PRMU20240407

EAST TOWN CROSSING
BUILDING 'A'
3002 E PIONEER WAY PUYALLUP WA 98372

AGENCY REVIEW - FIELD REVISION No.1 | 25.07.29

REVISIONS	
01	RESPONSE TO 1ST REVIEW: 2024.06.05
REVISIONS	
DRAWN BY: BL / CM	
CHECKED BY: BL	
DATE: 25.07.29	
TITLE: SITE PLAN - REF. ONLY	
PROJECT #: 2016	
SHEET:	
AS1.0

4 OVERALL SITE PLAN - PHASE 2
SCALE: 1" = 40'

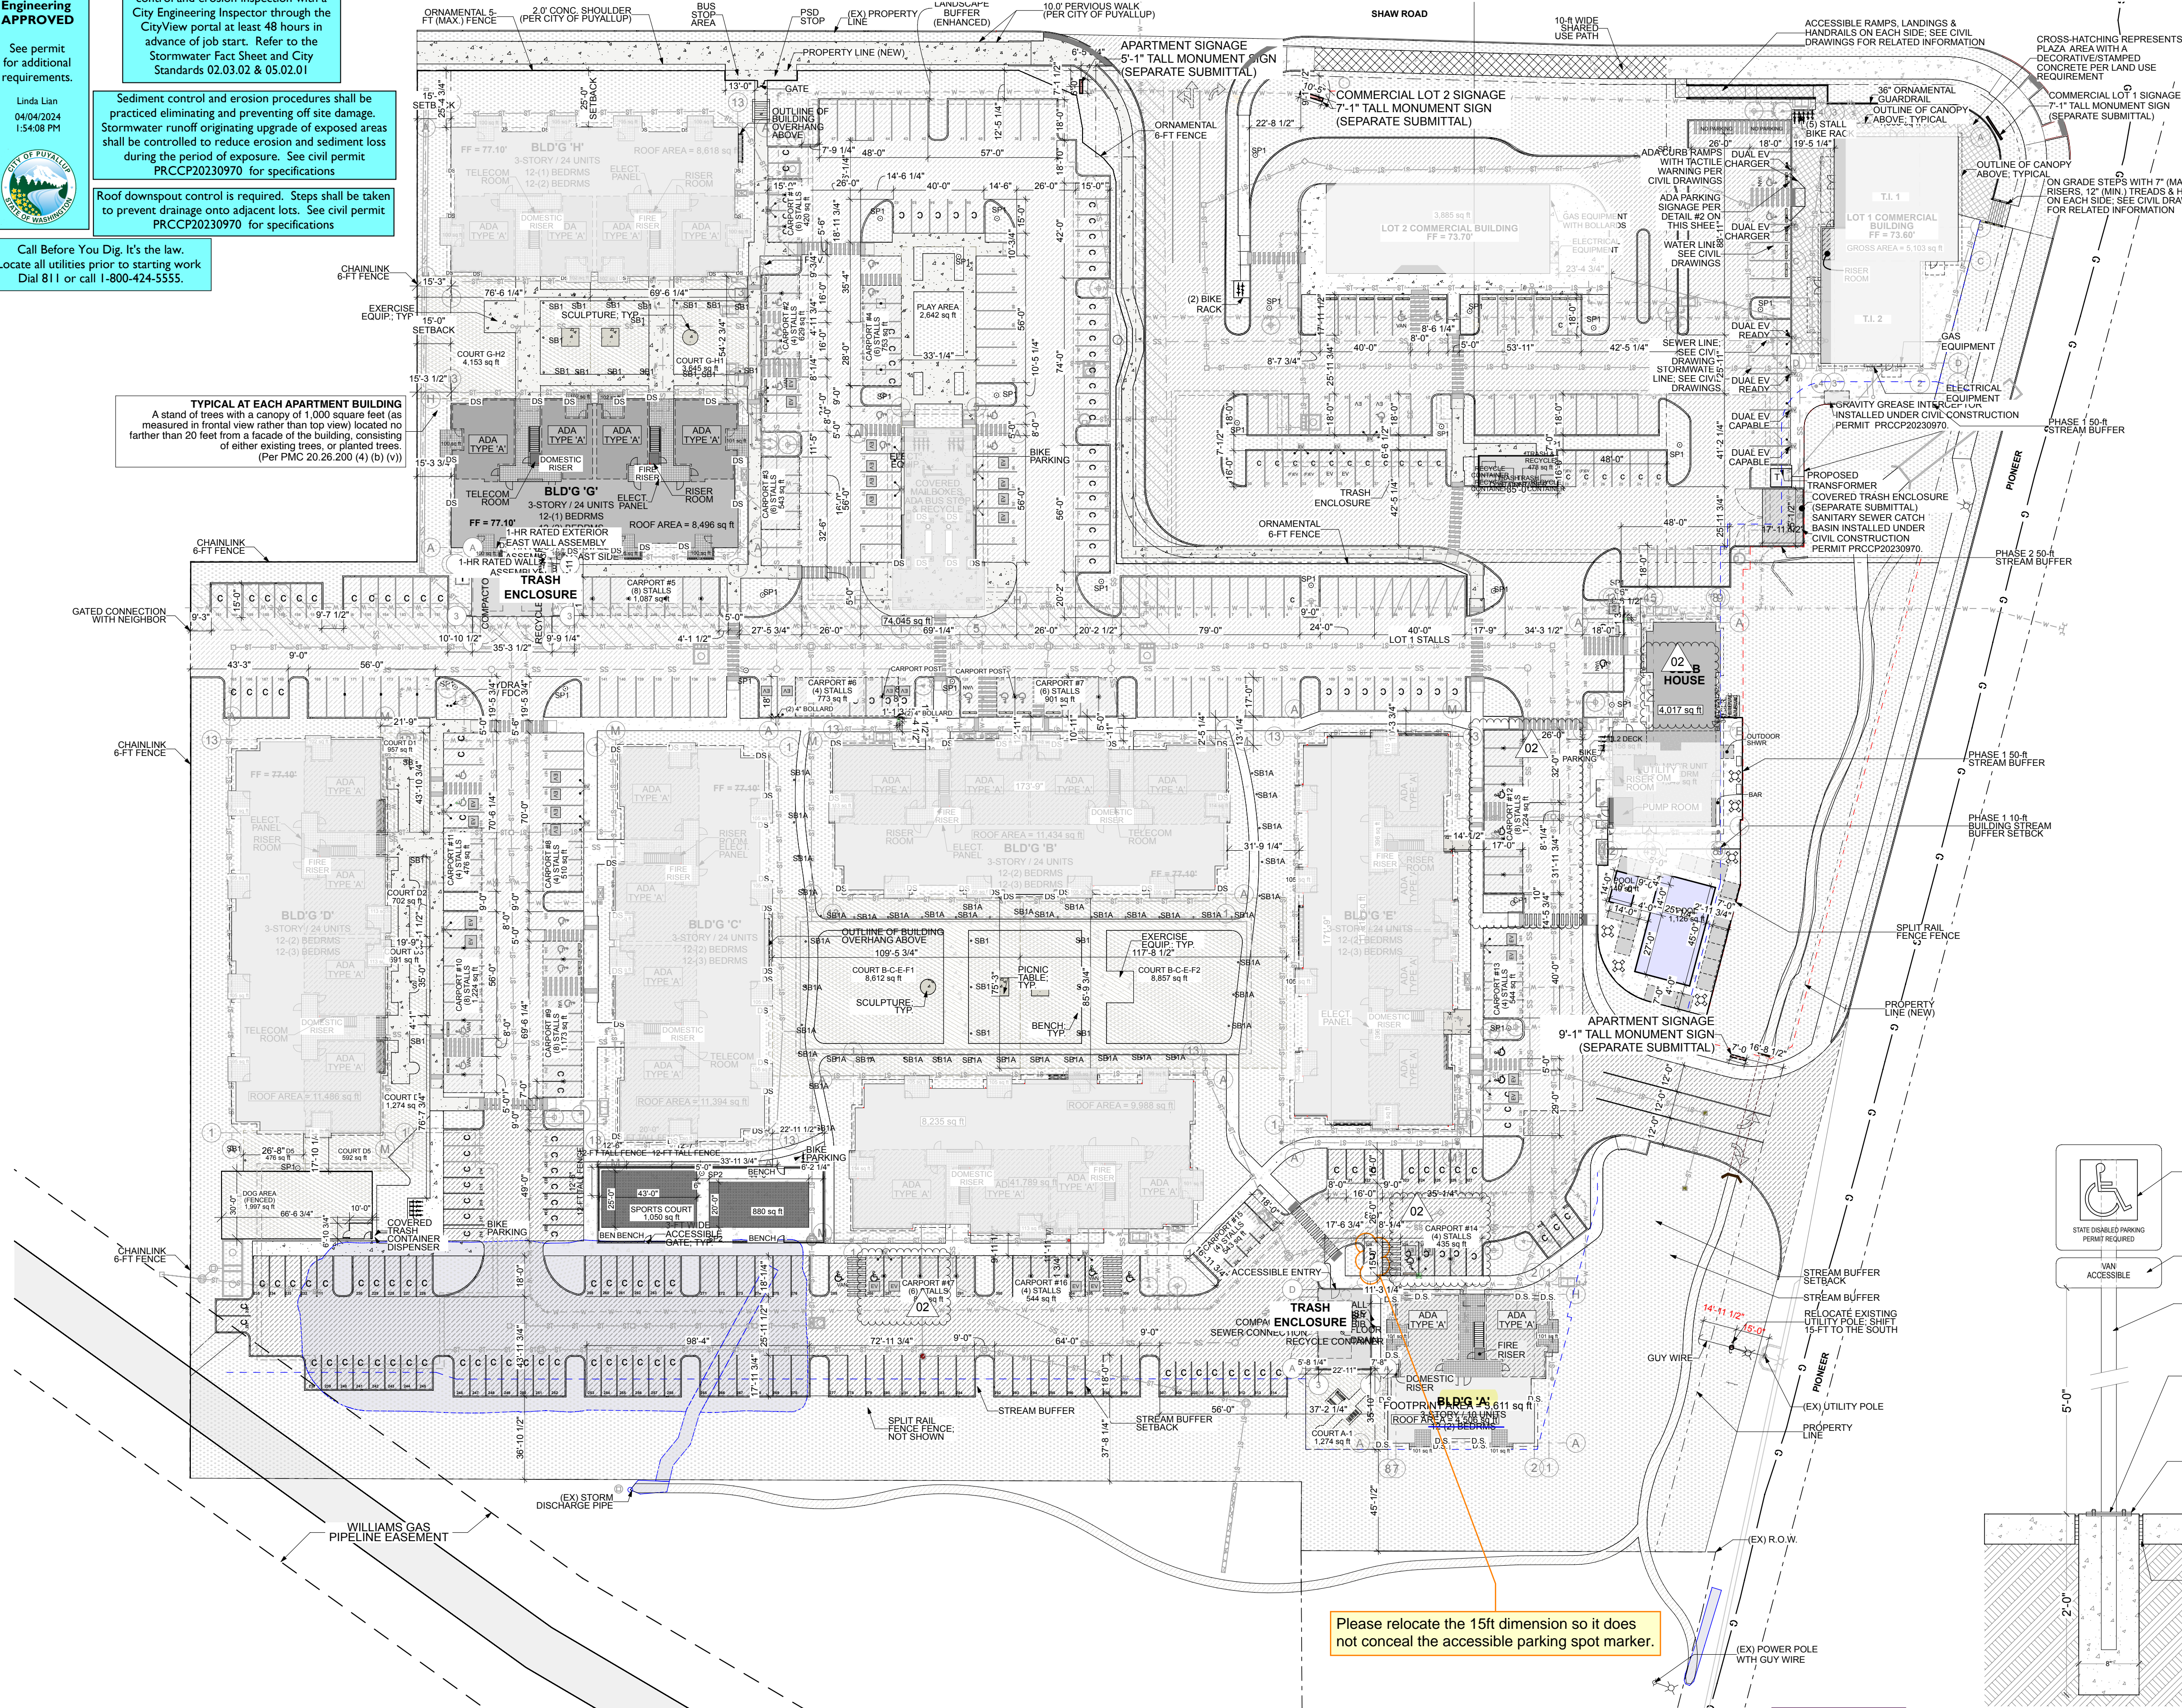
Please relocate the 15ft dimension so it does not conceal the accessible parking spot marker.

Setbacks to stream and property line approved, as shown.
